MAYFLOWER PLATINUM

Details of Additions & Alterations

Flat No	604	Block no.	'A'
Flat Area	1500 sft	Type	Deluxe / Luxury
Buyer Name	S. A. Zaheer Ahamed		
Phone No.	9561012056 / 9866514239	Email	zaheer ahamed 223.Zas@gmail.com

WORKING DRAWING OF FLAT NO. A-4

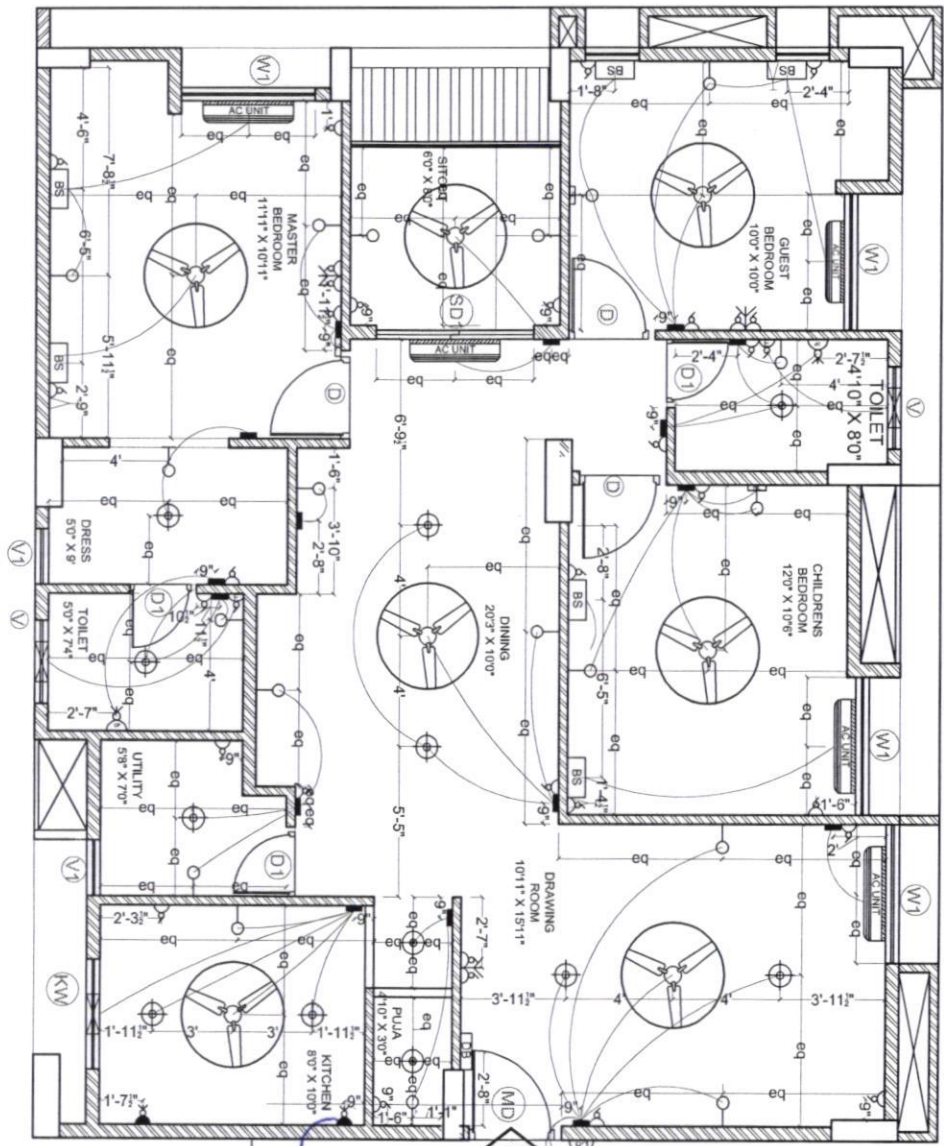
- ① Indian VILC in mbr
- ② Bathroom tiles same as A-105 (model flat)
- ③ Extension of attach washroom in master bedroom to 1 feet (marked on plan)
- ④ Common washroom EWC, washbasin and shower point to be changed (marked on plan).
- ⑤ Wash basin to be shifted in dining area marked on plan.
- ⑥ Kitchen sink, wash basin for dining room, western and indian commodes will be provided by us.

① Extension of loft marked in plan.

- ① Removal of internal wall between kitchen and pooja room for kitchen extension.
- ② Indian commode in attach washroom (Master bedroom)
- ③ Exhaust fans in 2 washrooms holes to be provided.
- ④ Four track french window in balcony with mesh.

A4
Lift to be extended.

ELECTRICAL PLAN OF FLAT-A4

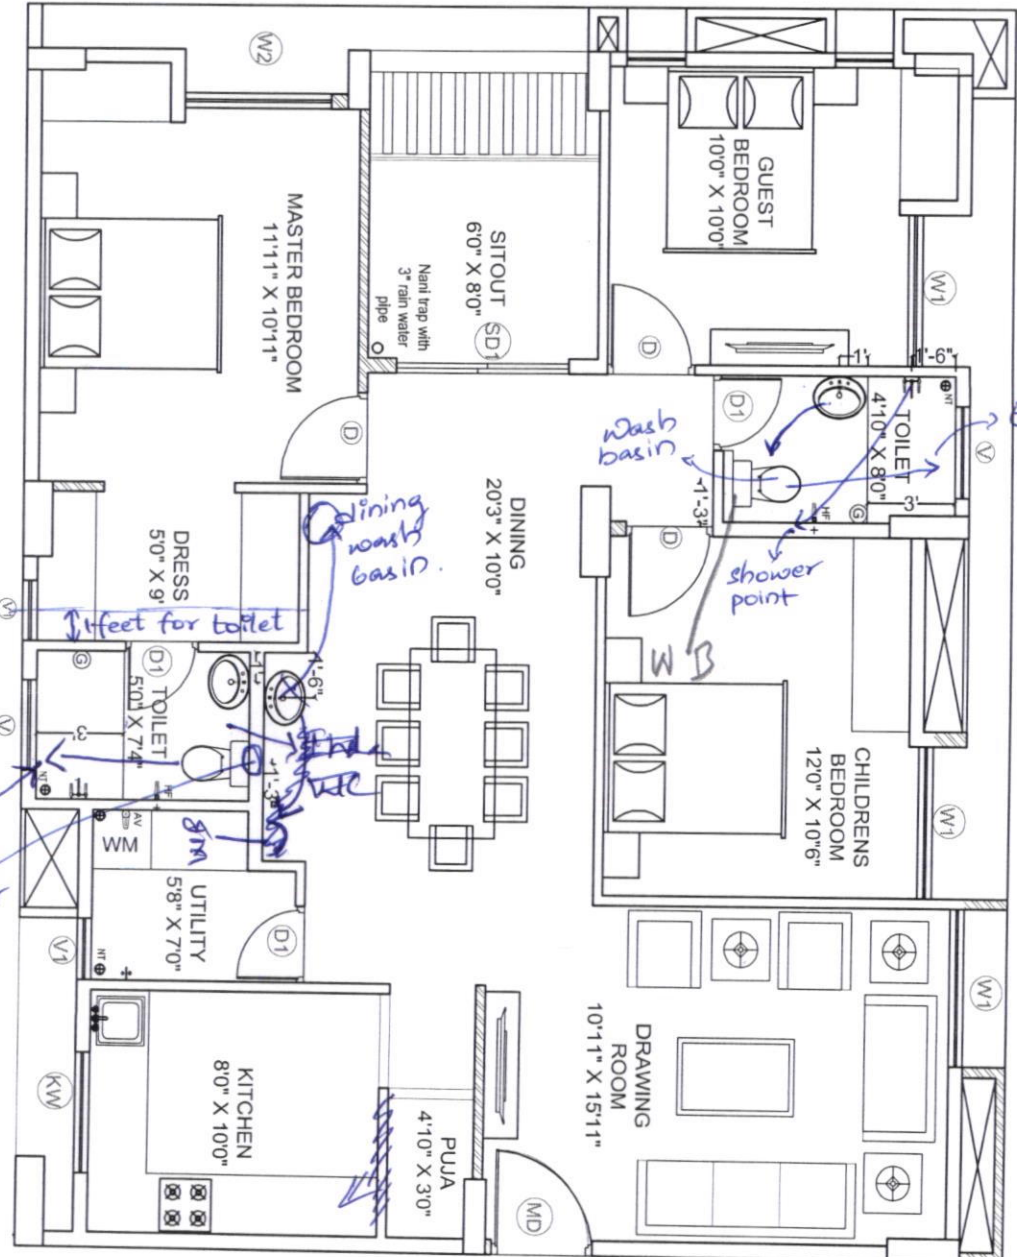
Extra 5 and 15 Amps socket and switch
